Dockets Nos. 50-280
and 50-281 ✓

The Commission has issued the enclosed Amendments Nos. 40 and 39 to Facility Operating Licenses Nos. DPR-32 and DPR-37 for the Surry Power Station, Units Nos. 1 and 2, respectively. These amendments consist of changes to the Technical Specifications for each license in response to your five separate applications dated September 27, 1976, May 19, 1977, May 20, 1977, October 18, 1977 and November 3, 1977.

AMENDMENT TO FACILITY OPERATING LICENSE

ATTACHMENT TO LICENSE AMENDMENT NO. 40

MAIN STEAM AND FEEDWATER LINES - UNIT 2
SURRY POWER STATION
UNITS 1 AND 2

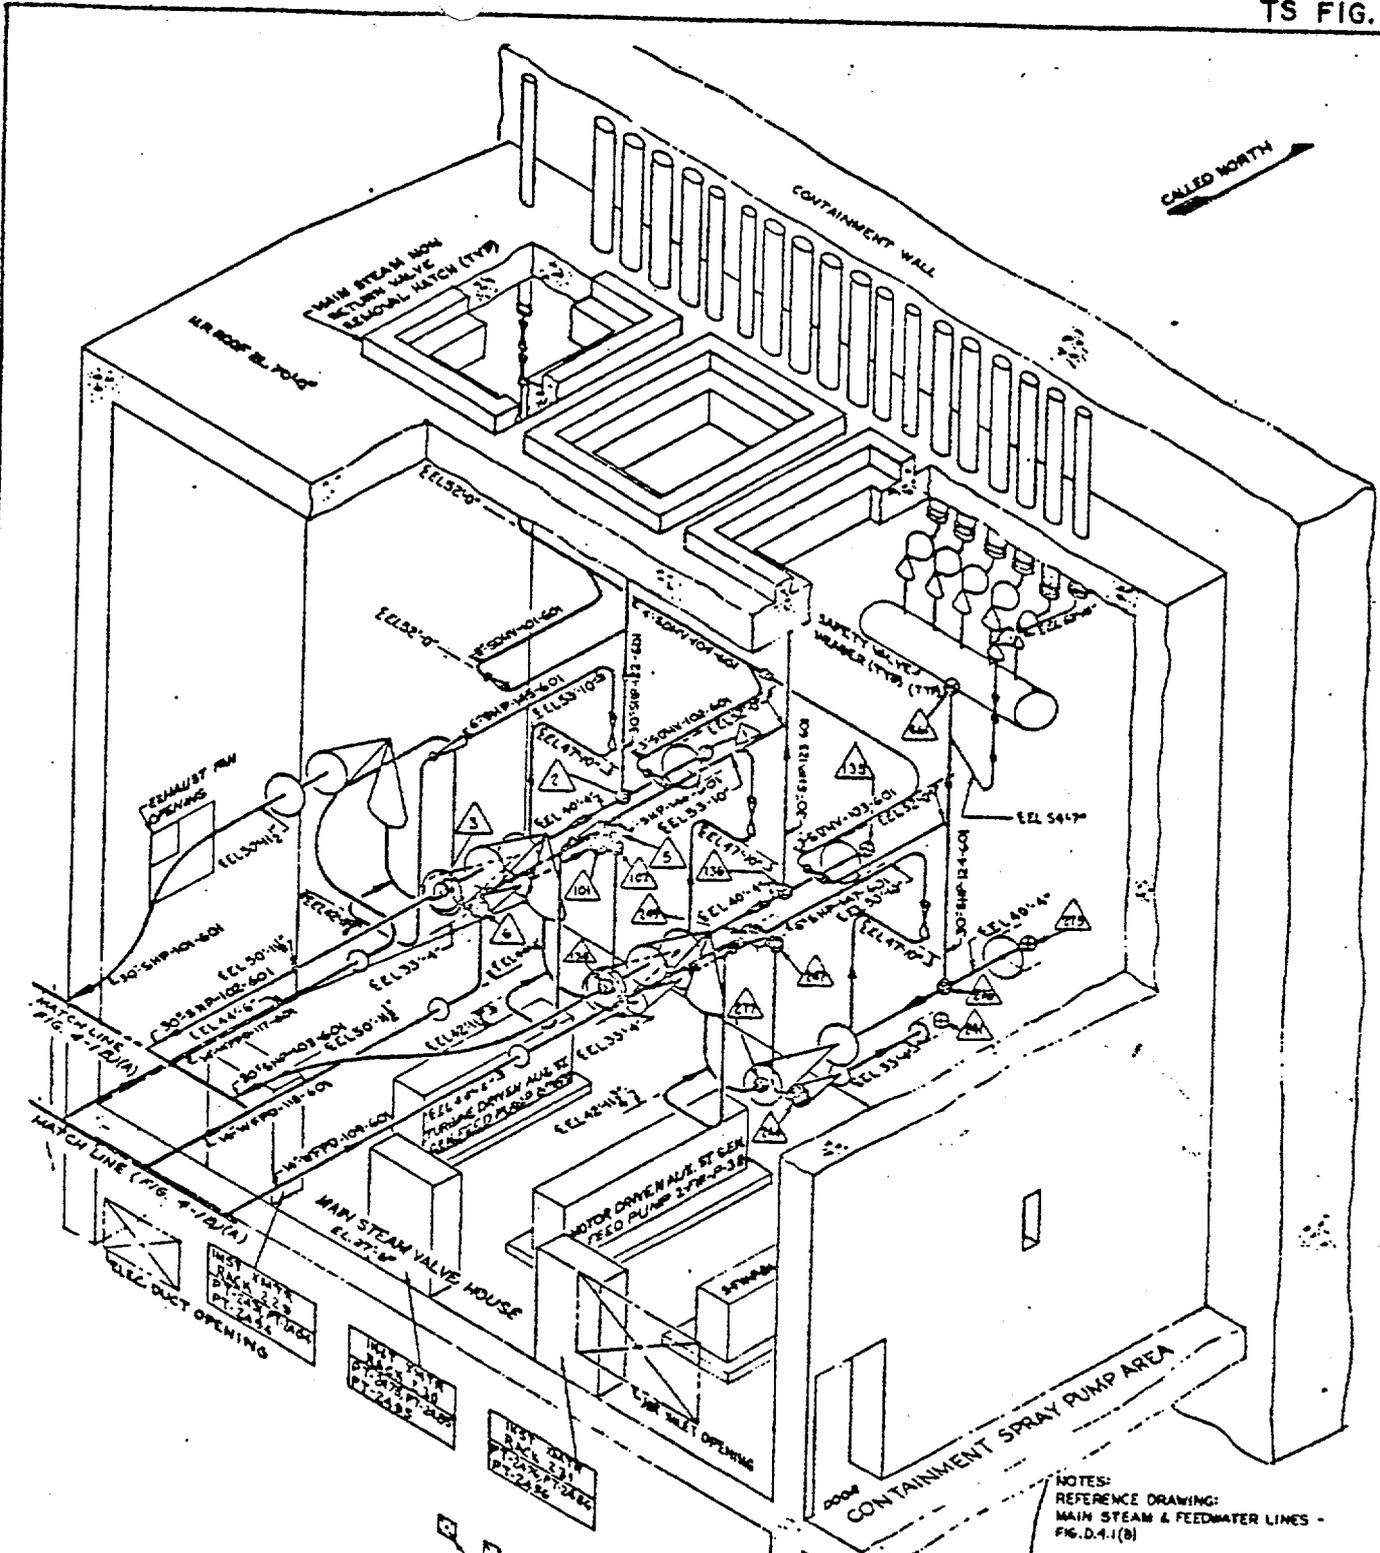
- A. For the 17 welds identified in TS Figure 4.15:
 1. At the first refueling outage period a volumetric examination shall be performed with 100 percent inspection of welds in accordance with the requirement of ASME Section XI Code, Inservice Inspection of Nuclear Power Plant Components, to

B. For all welds other than those identified in TS Figure 4.15:

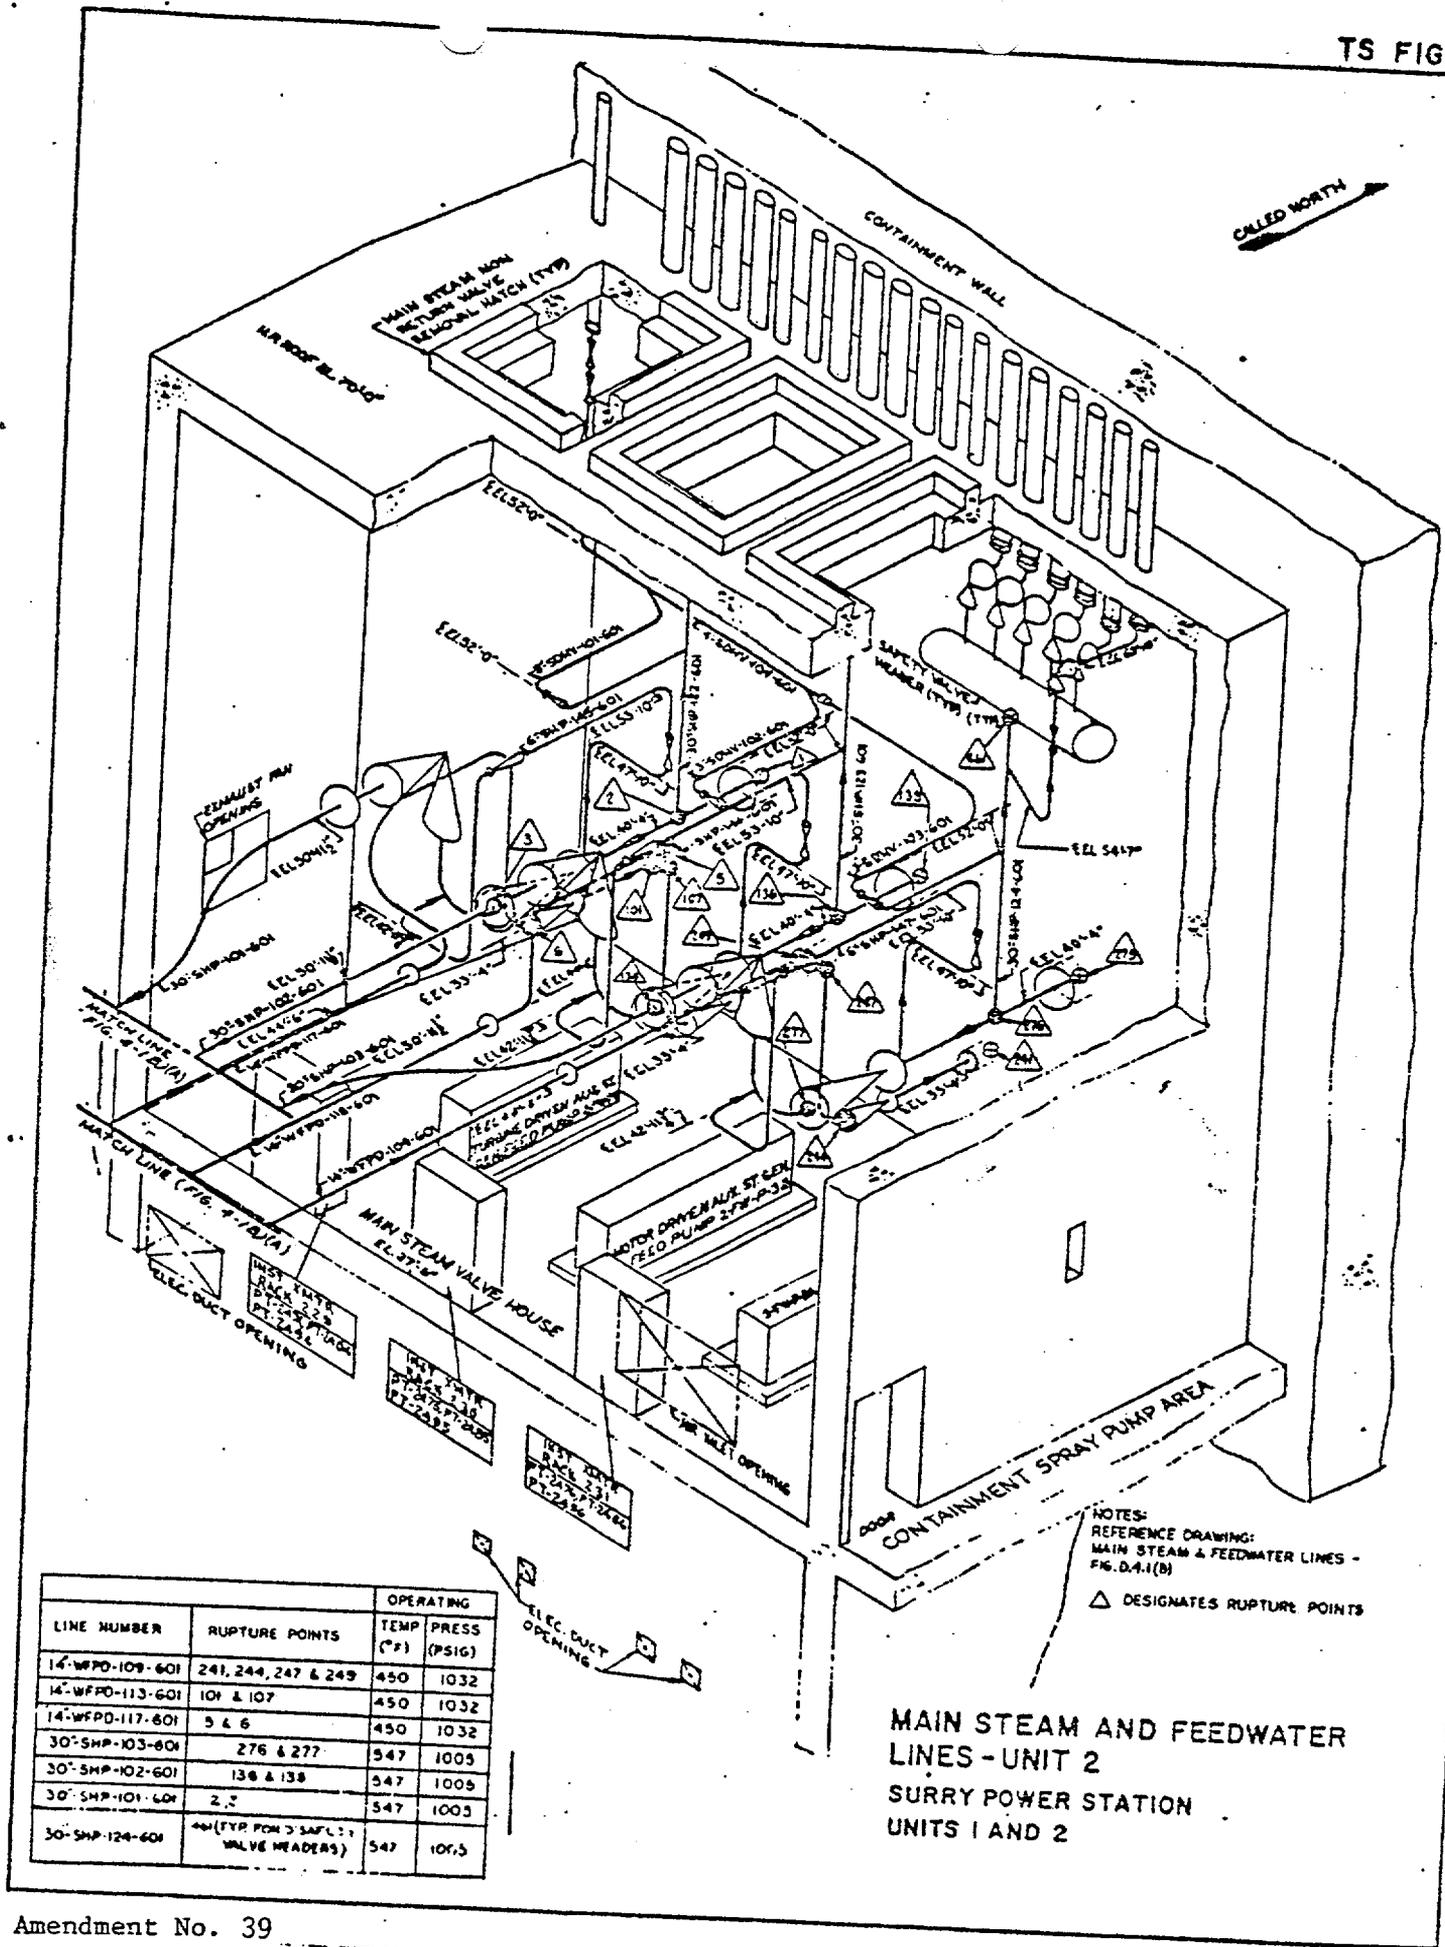
- A. For the 17 welds identified in TS Figure 4.15:
 - 1. At the first refueling outage period a volumetric examination shall be performed with 100 percent inspection of welds in accordance with the requirement of ASME Section XI Code, Inservice Inspection of Nuclear Power Plant Components, to

B. For all welds other than those identified in TS Figure 4.15:
